## Astor Place Plazas, January 2011 Community Board #2 Manhattan – January 20, 2011 Hand-Out

For the purpose of offering DOT, DDC, Parks and the Designers more specific references upon which they can refine their proposal for further community review, we offer comment on some current renderings and the following suggestions:

# Astor Place Subway Entrance, Jan 2011

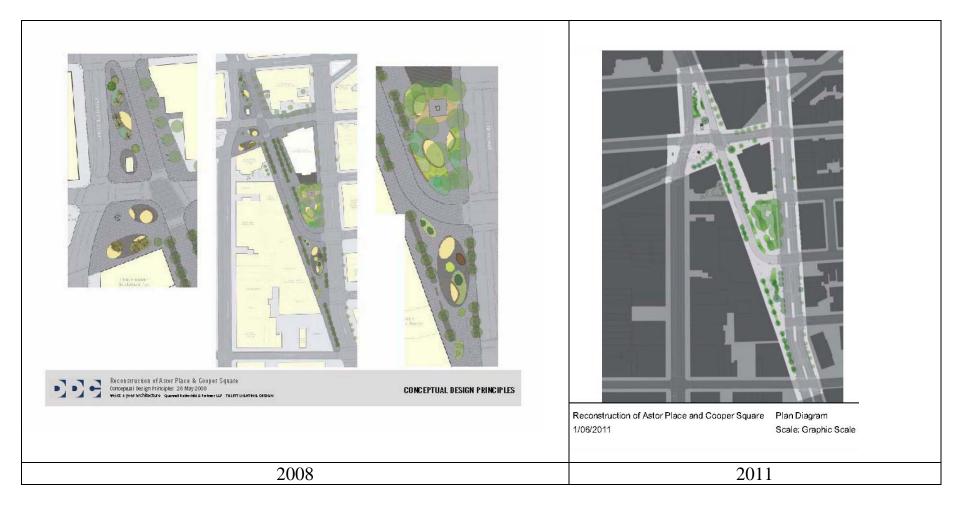
Seating steps around all plantings, residences large resident apartment buildings north west east and south, wide sidewalks possibly accommodating unregulated 1<sup>st</sup> amendment street vendors, performance artists or programmed installations unless restricted
